**Report to General Manager**

SUBJECT: Bannerman Street, Cremorne Pedestrian Crossing – Consultation Outcomes

AUTHOR: Lindsay Menday, Sustainable Transport Projects Coordinator

Figure 2. Concept for 'Option 1' Raised Crossing in Existing location

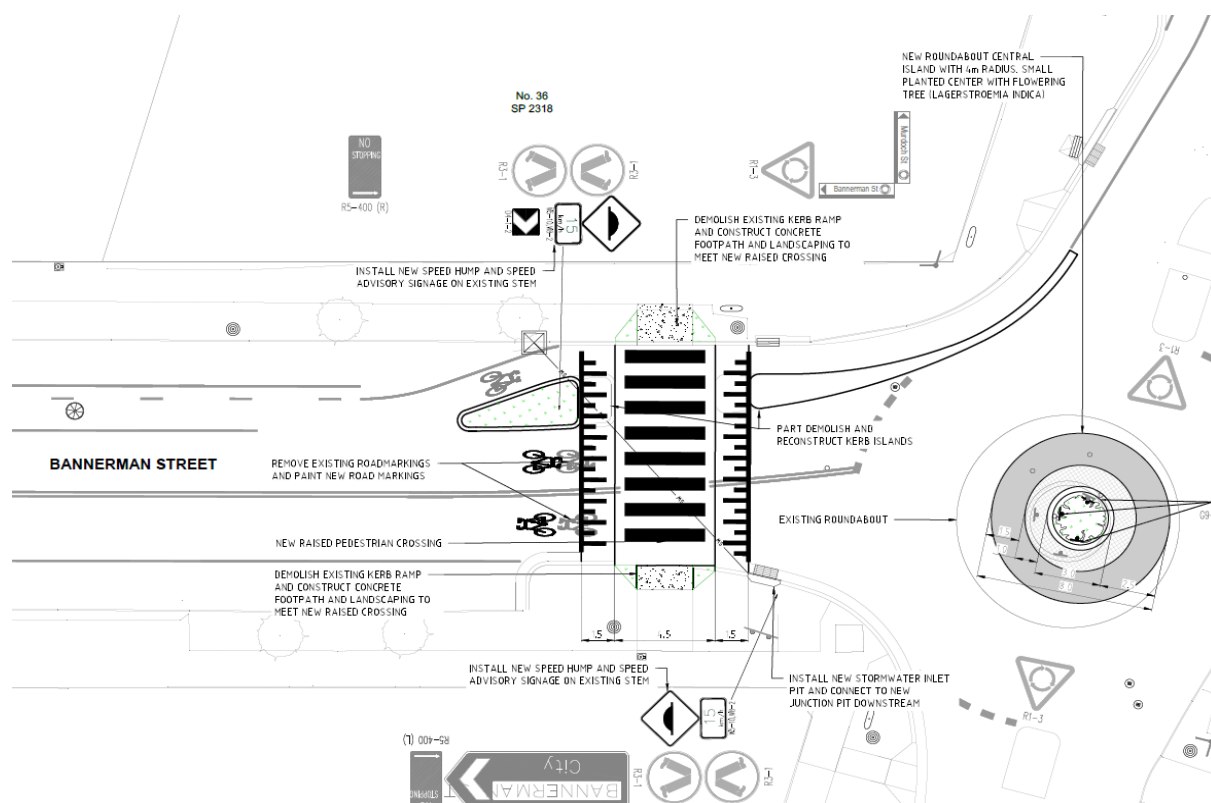
| Number | Submission | Key Issue Raised | Comment |
|--------|--|---|--|
| 5. | I strongly agree with raising the crossing. I also think it would be far safer to be moved 10m west as its currently much too close to the roundabout - making it unnecessarily dangerous for the pedestrians and also causing back logs on the roundabout when a car has to stop at the crossing. | Support for Option 2 | Community consultation identified broad support for improvements to the crossing in the current location |

| 9. | The crossing should have been installed at the newly proposed location initially. It is very dangerous with vehicles exiting the roundabout to find a pedestrian almost immediately in front of them. The additional 10m will give drivers a chance to refocus on the road and the crossing. | Support for Option 2 | Community consultation identified broad support for improvements to the crossing in the current location |

| 13. | <p>Moving the crossing will be dangerous as pedestrians will continue to cross at the junction of Murdoch and Bannerman Street</p> | Opposition to Option 2 | Community consultation identified broad support for improvements to the crossing in the current location |

| 14. | Raising the crossing in its current location will stop pedestrians in a hurry trying to cross there rather than walking down Bannerman Street a short distance to a crossing. Raising it will make it more visible. | Support for Option 1 | This report recommends implementation of Option 1 |

| 24. | In the same place, cars will slow down. Makes it safer as cars slow down before entering traffic circle | Support for Option 1 | This report recommends implementation of Option 1 |

Figure 3. Concept for 'Option 2' Raised Crossing Approximately 10m West of the Existing Location

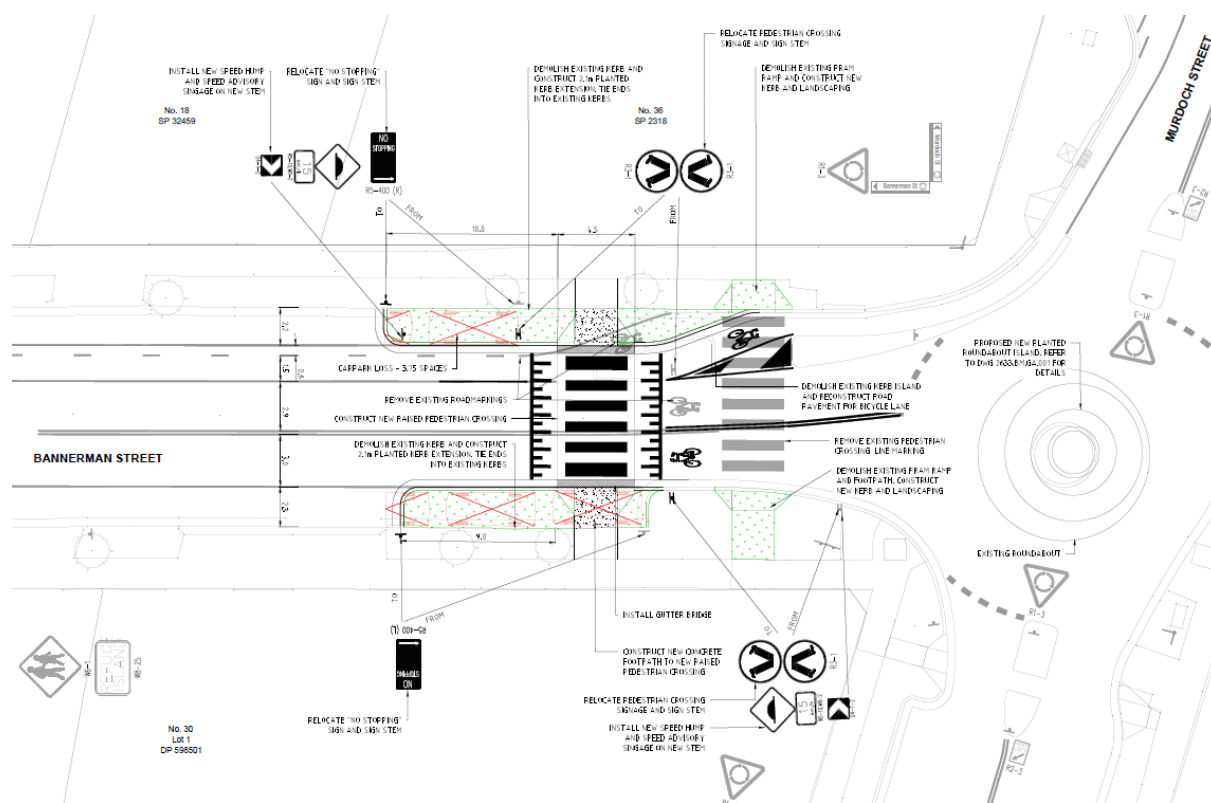
| 12. | <p>Thank you for the opportunity to comment. We support the proposal to install a raised pedestrian crossing further west (10M plus) of the existing location as the current location poses a traffic hazard. The current location of the pedestrian crossing is in an awkward position as imminent pedestrians are blind to motorists and often cause a late reaction which cannot be anticipated when turning right from Murdoch St into Bannerman. It would also be ideal if the proposed raised crossing had handicap access. There are many young families in this area and the current pathways particularly around Cremorne Point which are not young family or pram friendly.</p> | Support for Option 2 | Community consultation identified broad support for improvements to the crossing in the current location |

| 16. | Option 2 would be safer as not so close to the roundabout which requires 100% attention in its own right | Support for Option 2 | Community consultation identified broad support for improvements to the crossing in the current location |

| 23. | If the crossing is moved further from the roundabout, pedestrians using Murdoch Street will cross at the roundabout (with accident risk) to avoid the detour | Opposition to Option 2 | This report recommends implementation of Option 1 |

| 41. | Moving the crossing is a very good idea for pedestrians and motorists. I am also thrilled to read of the planned 'speed cushions' trial as none of the other work has made any difference to road speed if it was meant to. | Support for Option 2 | Community consultation identified broad support for improvements to the crossing in the current location |
